Zone Change

Montville, Connecticut

REPORT

Review Date: JULY 17, 1986

Revised from New London County Soil Survey Sheet #53

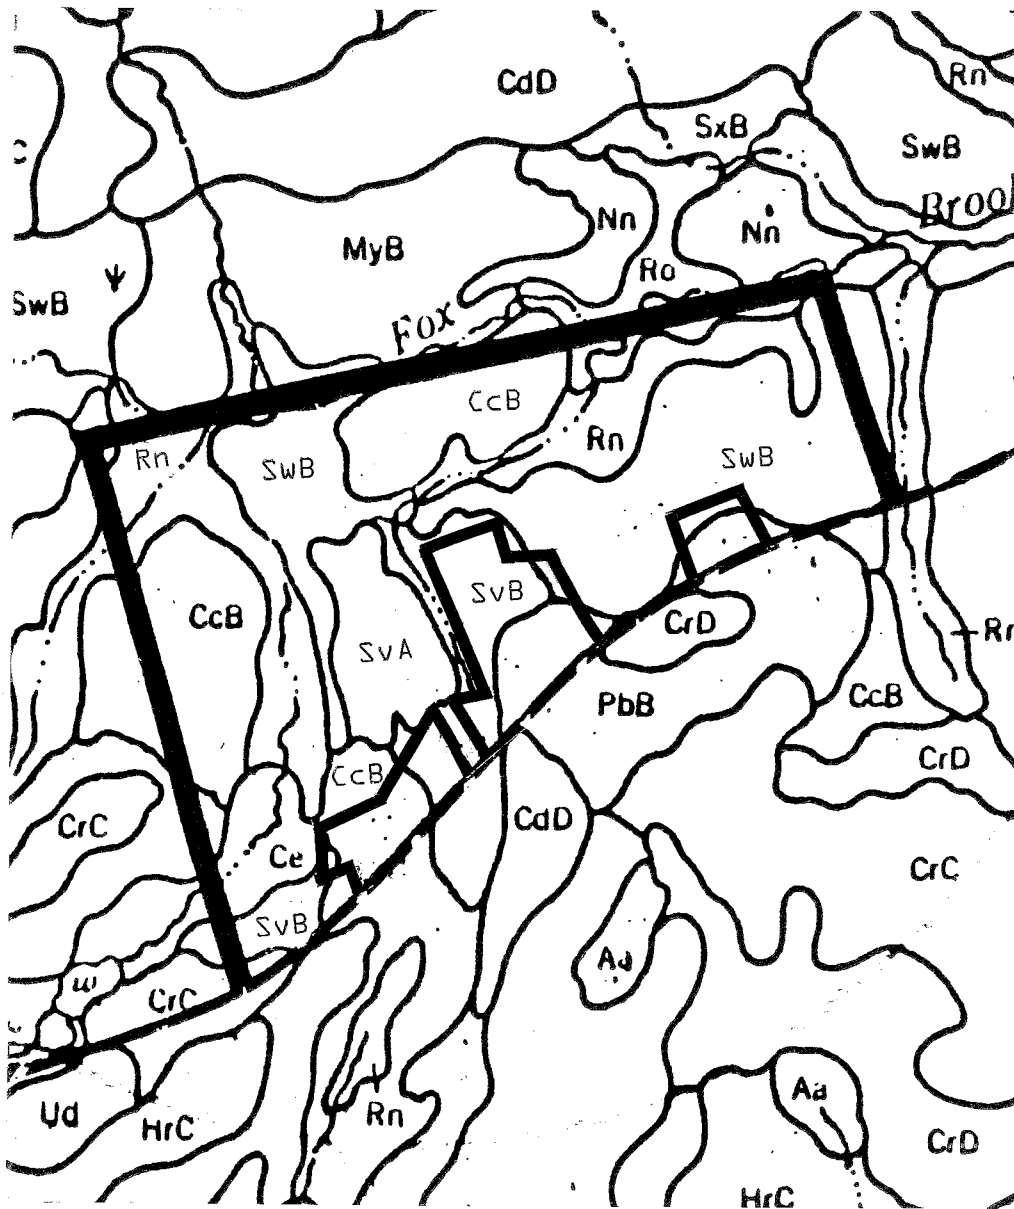
The attached soils map shows the general distribution of the soils on this tract of land. Specific areas of wetlands will need to be flagged in the field prior to any construction. The wetland extent can only be accurately determined after they are field marked.

Please note soil symbols and name changes made on this map. Boundary line of property is only an approximate.

WATERSHED BOUNDARY

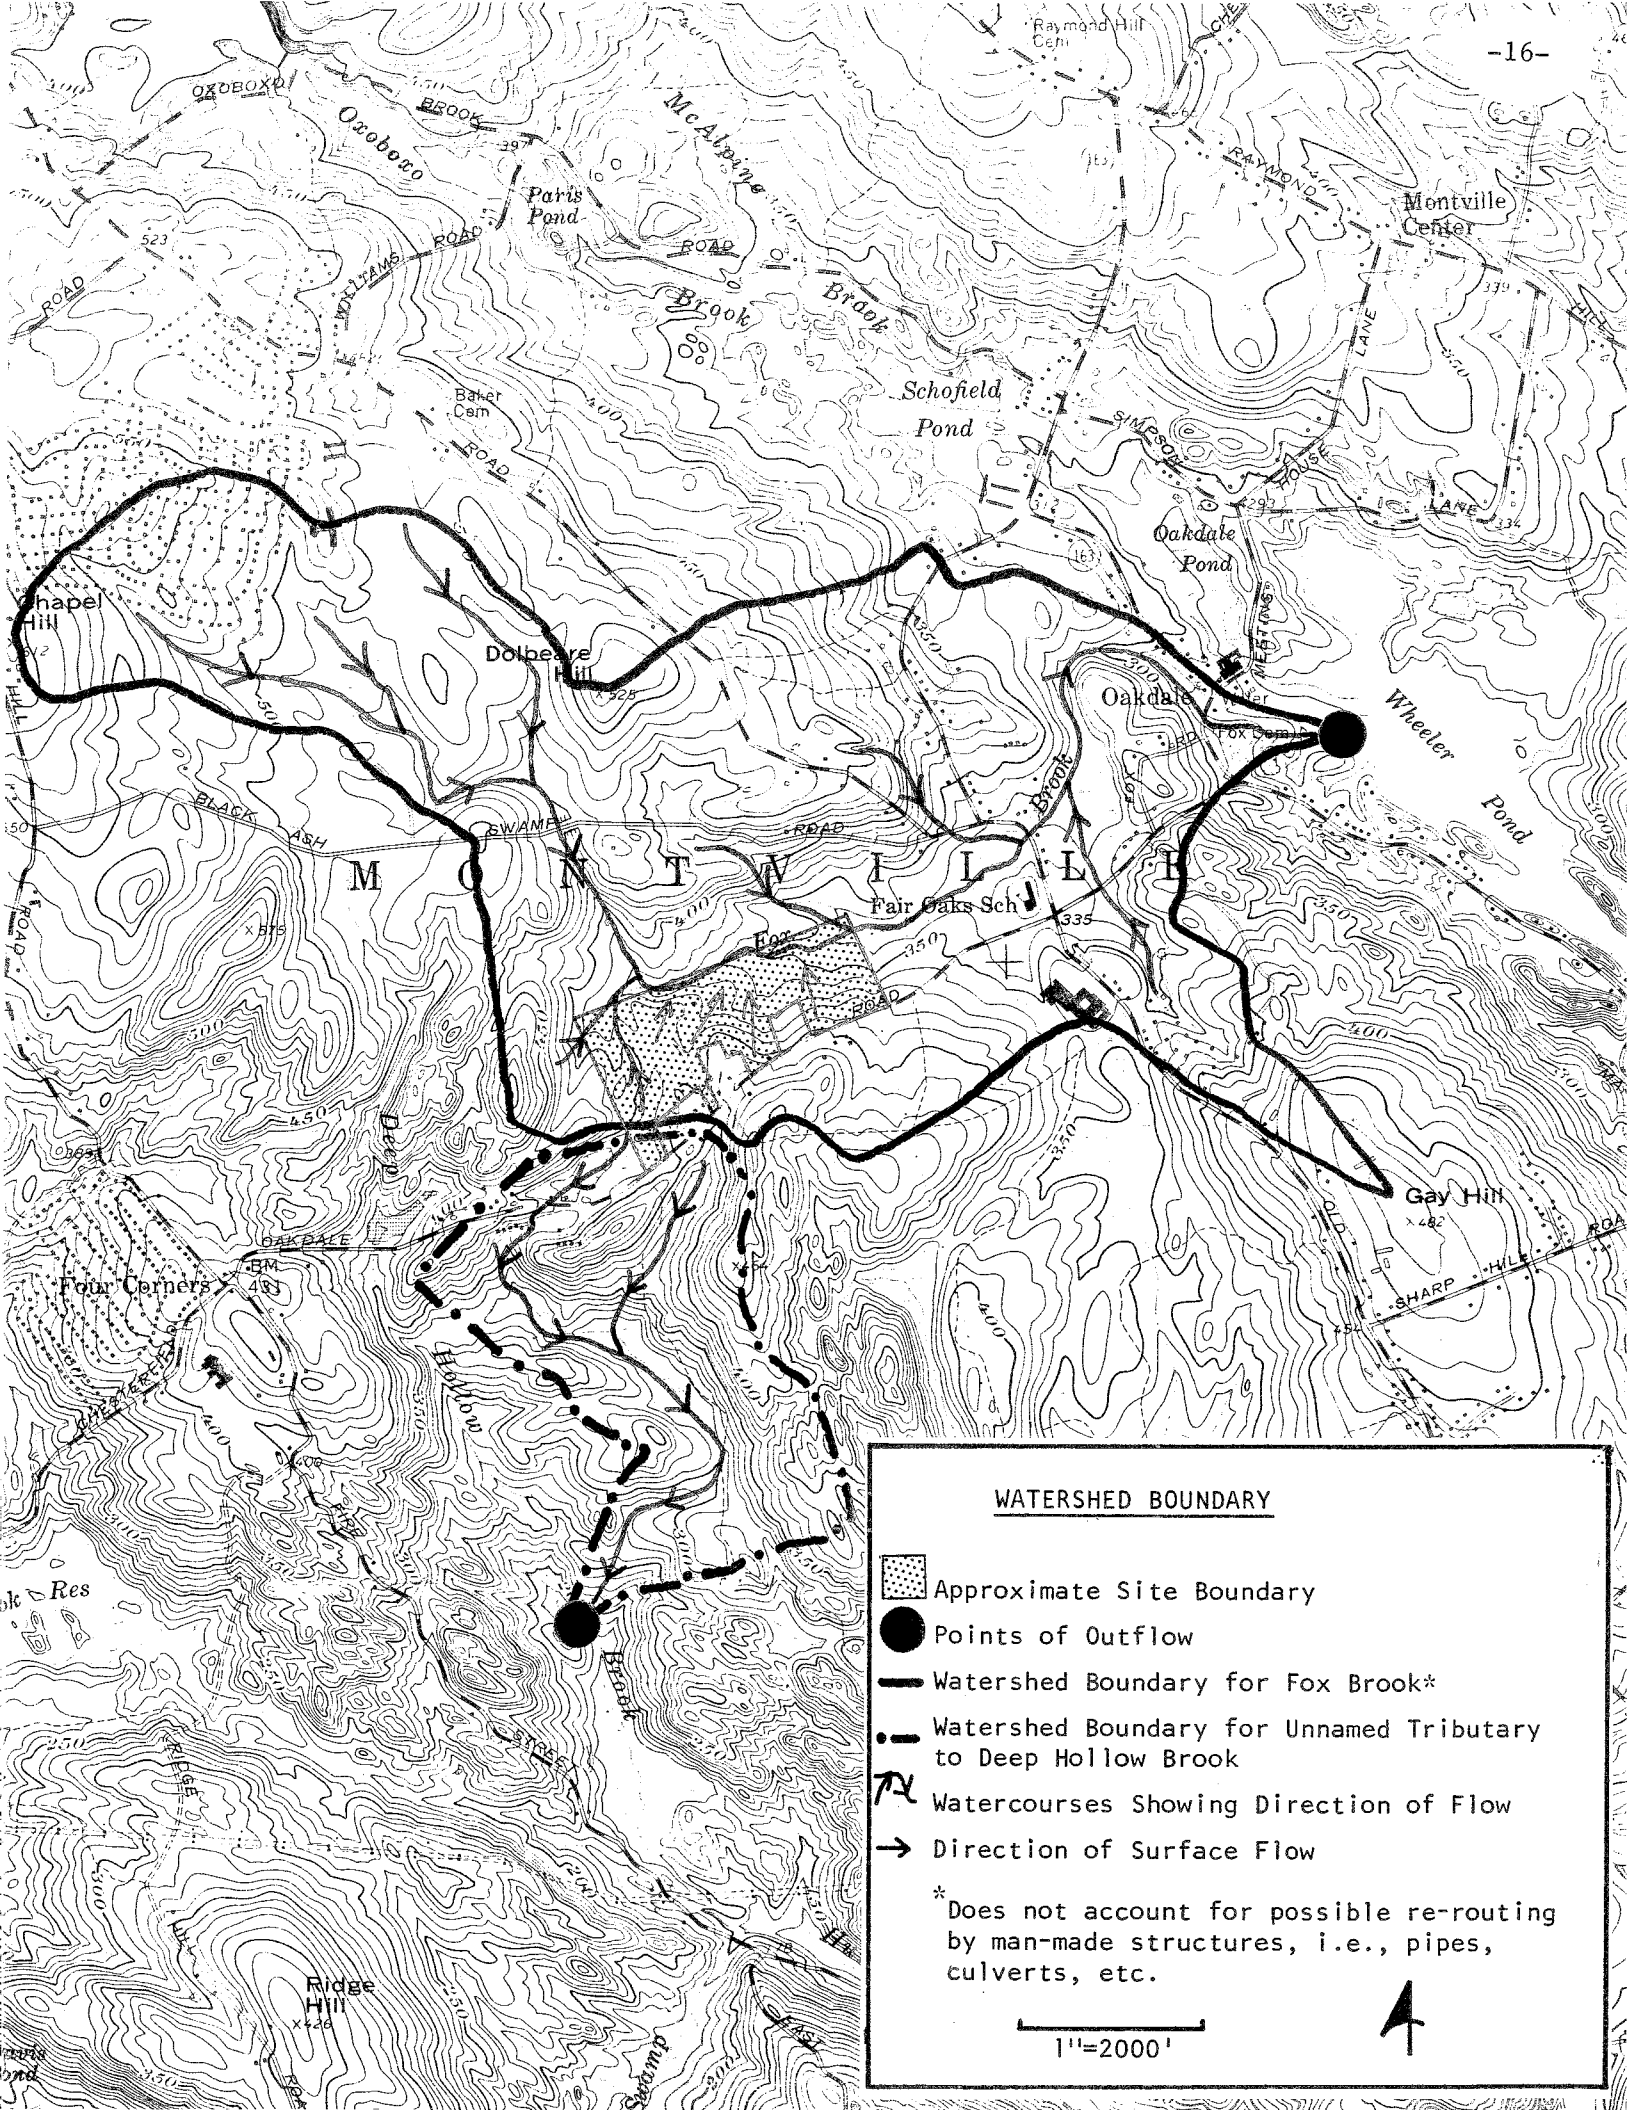
Except for 45 acres in the southwest corner of the site, surface runoff and probably to a large extent groundwater flow is to Fox Brook. Fox Brook and an intermittent drainage channel on the site act as discharge points for runoff. Fox Brook, which flows along the property line in the northern limits in an easterly direction, ultimately discharges into Wheeler Pond to the east.

Surface runoff and groundwater from the remaining + 45 acres in the southwest corner flows into a swampy area southwest of the site. It is then routed southward under Oakdale Road into an unnamed tributary to Deep Hollow Brook.

Construction of the site under the R-20 zone versus the R-40 zone can be expected to lead to increases in runoff from the site and to increase peak flows in the local watercourses. This is mainly due to the greater density which would be allowed under the R-20 zones.

In this regard, it is recommended that the applicant be required to submit detailed hydrological information on pre- and post-development runoff volumes and peak flows from the site, prior to subdivision approval. Estimates should be provided for a 10, 25 and 100 year design storm. Detailed design specifications for all stormwater control facilities (if considered) should also be submitted. All storm drain outlets should include an energy dissipator to help protect areas below the outlet from gullyng. A conscientious erosion and sediment control plan should accompany the stormwater management plan for each section of the development.

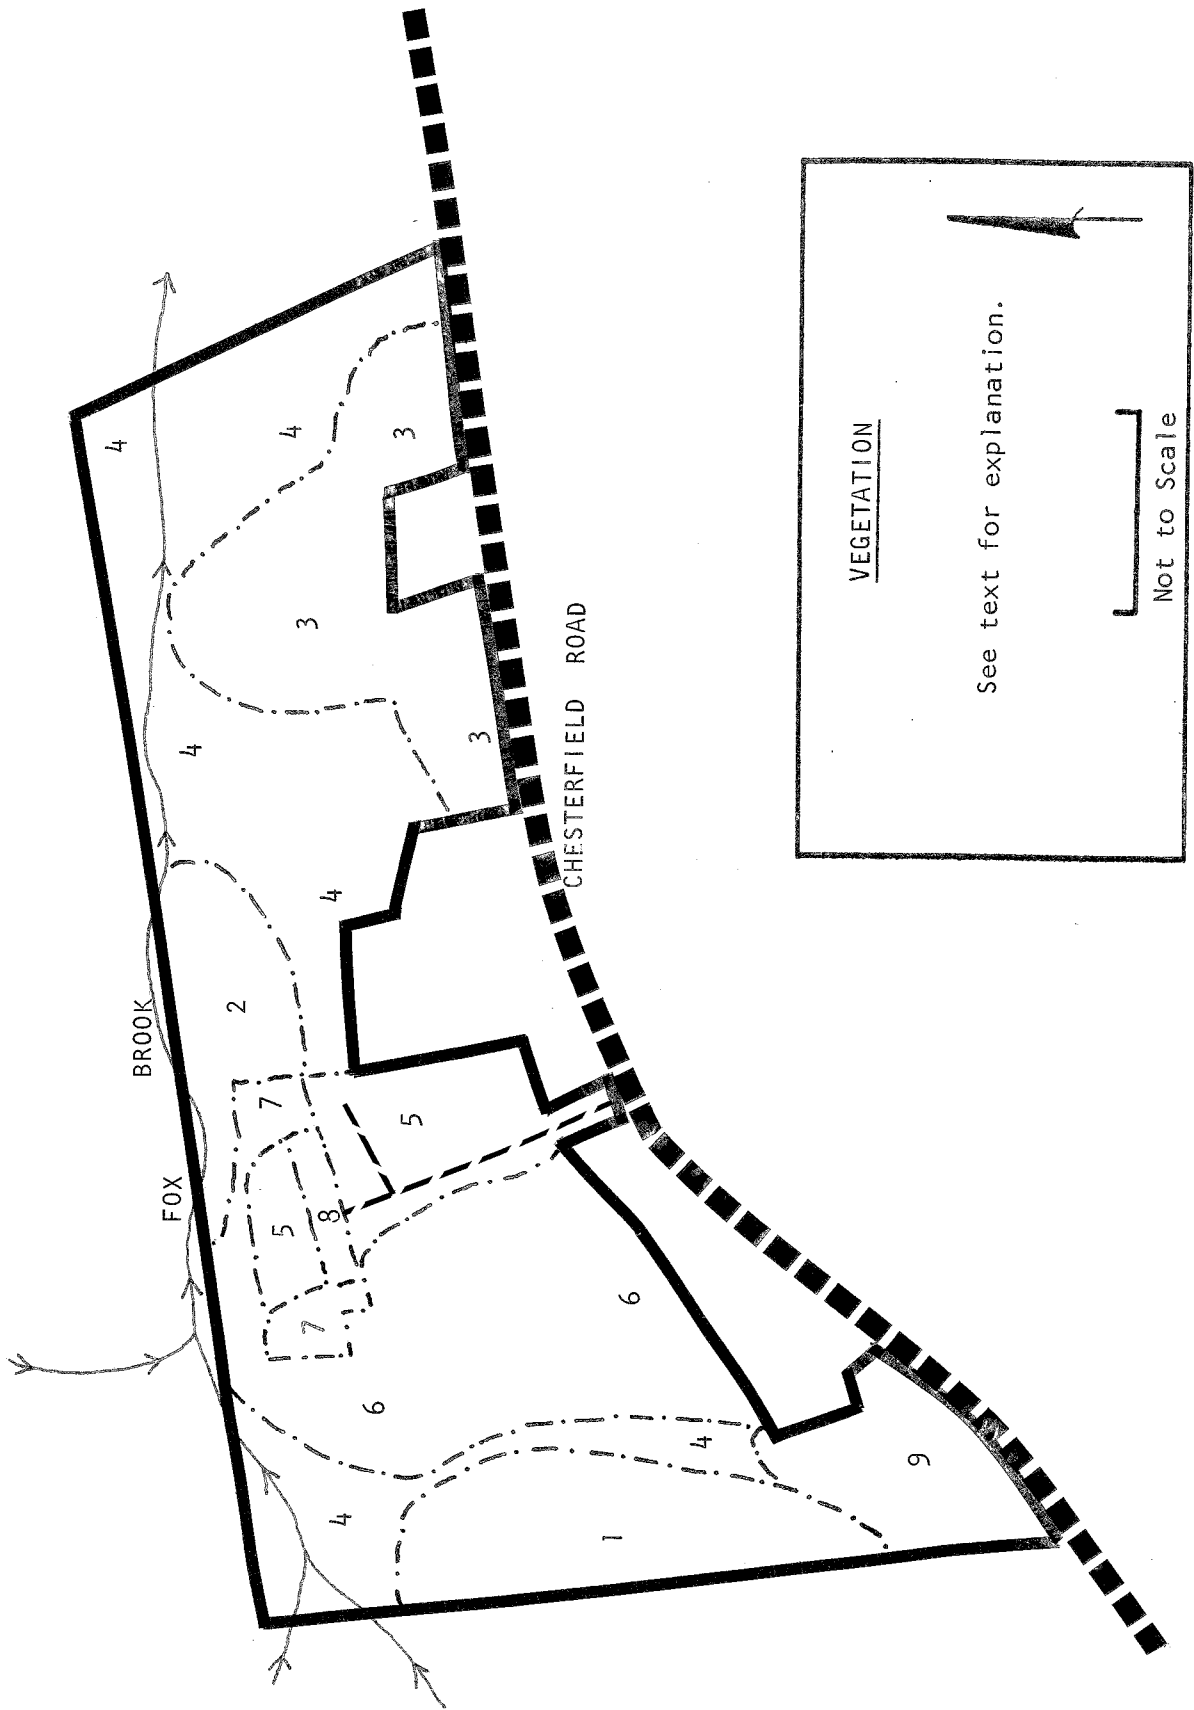
--A serious problem exists in the general area of #4 (See vegetation map). By opening this area up with roadway and homes, this will make the trees sitting on these shallow wet soils very susceptible to wind damage and uprooting.

PRELIMINARY
 SUBDIVISION SKETCH
 ULTIMATE CUSTOM STRUCTURES
 CHESTERFIELD RD. MOUNTVILLE, CONN.
 JULY, 1986

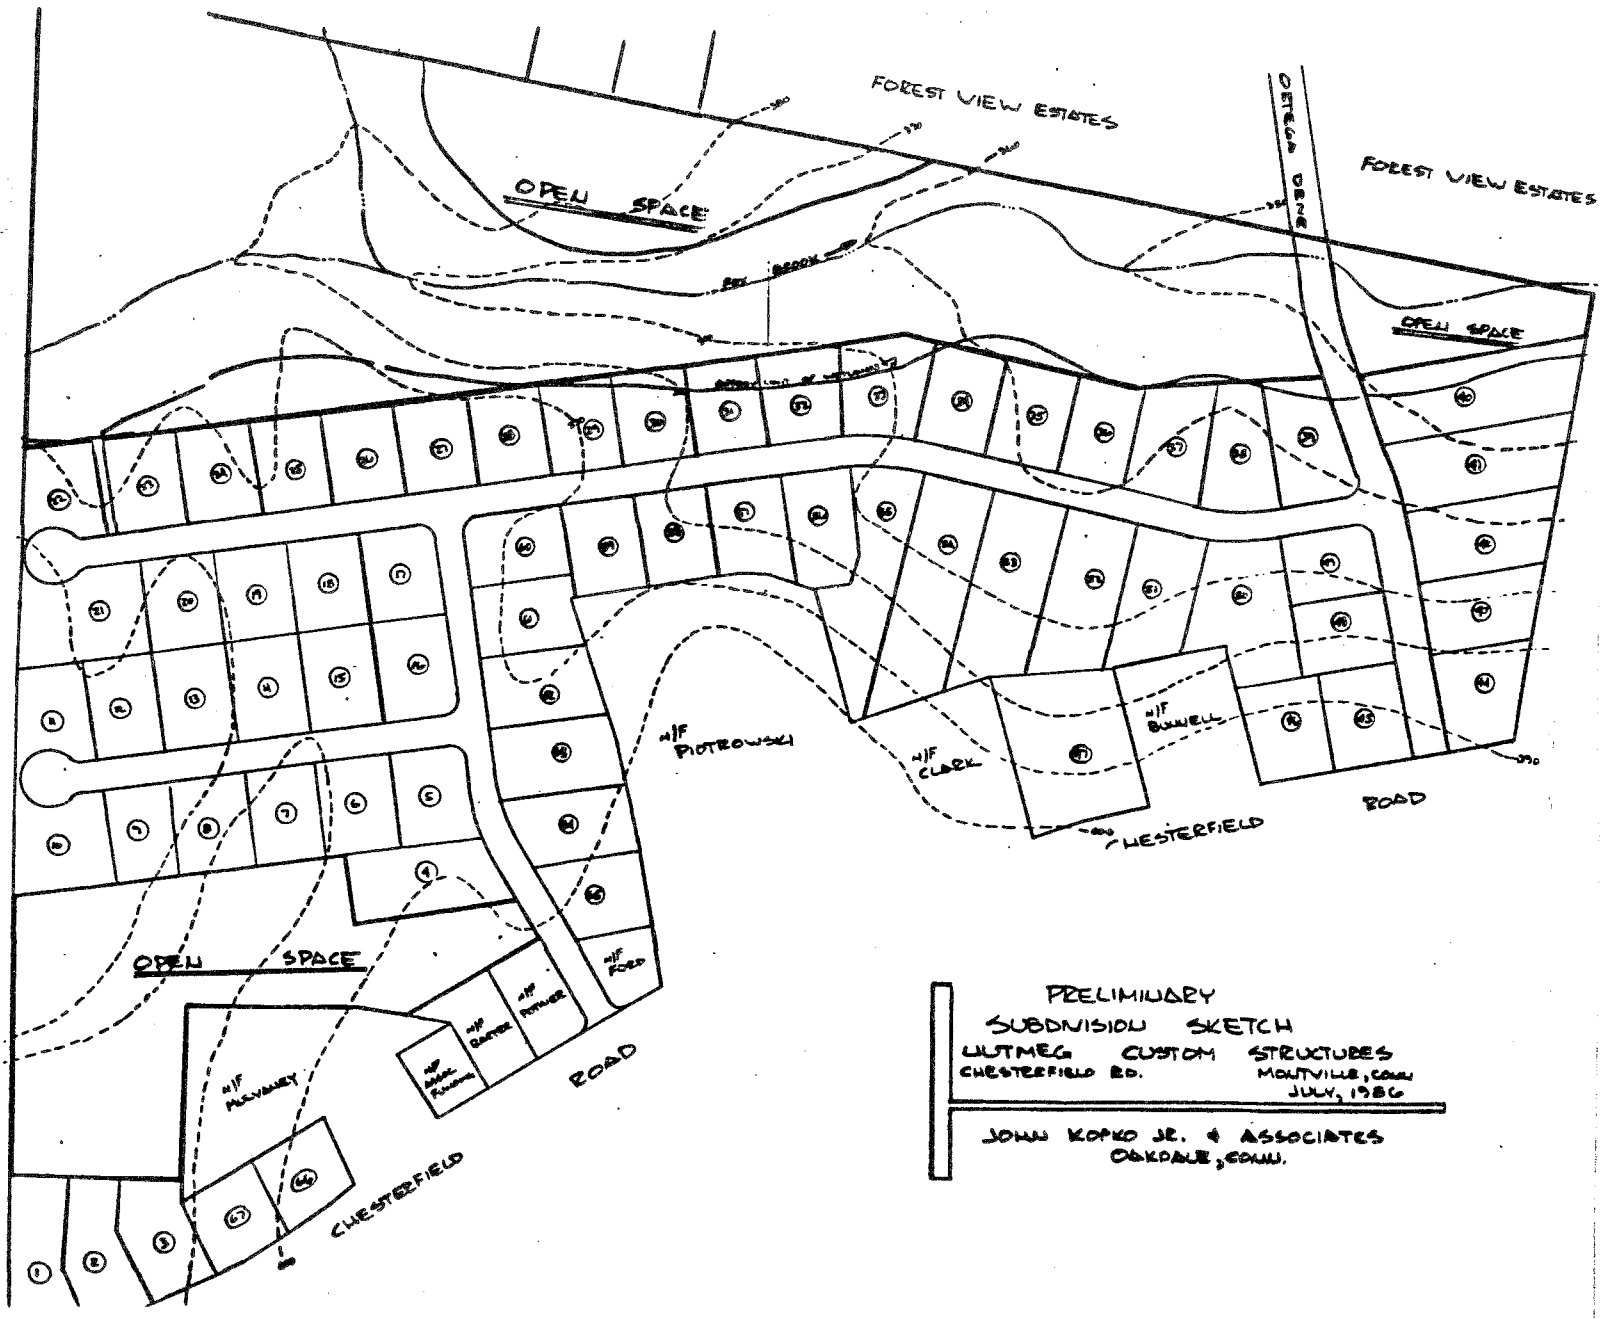
The area is depicted as low- and medium-density residential on the Town Plan of Development with suggested densities of less than one (1) to four (4) units per acre. The Regional Development Plan recommends low-density and mixed suburban uses for this area with densities of less than one (1) to two (2) units per acre. The lower density areas reflect the wetlands along Fox Brook at the rear of the property. With the availability of public sewers, half acre zoning should be feasible. The RA-20 Zone in addition to single-family homes also allows multi-family dwellings at 10,000 square feet per dwelling unit. The applicant has indicated that this provision will not be utilized with only single-family homes intended for the area.

Chesterfield Road is classified as a collector street in the Montville Plan of Development. No improvements are suggested for Chesterfield Road in the vicinity of the zone change in either the Montville Plan of Development or in the Regional Transportation Plan. No traffic counts exist for local roads in Montville. Data published by ConnDOT* indicate that a residential subdivision can be expected to generate 10.6 weekday trips per unit. Of this number, 7.9% can be expected to occur during the morning peak hour and 10.1% during the evening peak hour. Sixty (60) new single-family homes could be expected to generate 636 daily trips. If the area of the zone change develops with new roads, consideration should be given to a connection with Ortega Drive to the north which would provide a north-south connection between Black Ash Swamp Road and Chesterfield Road.
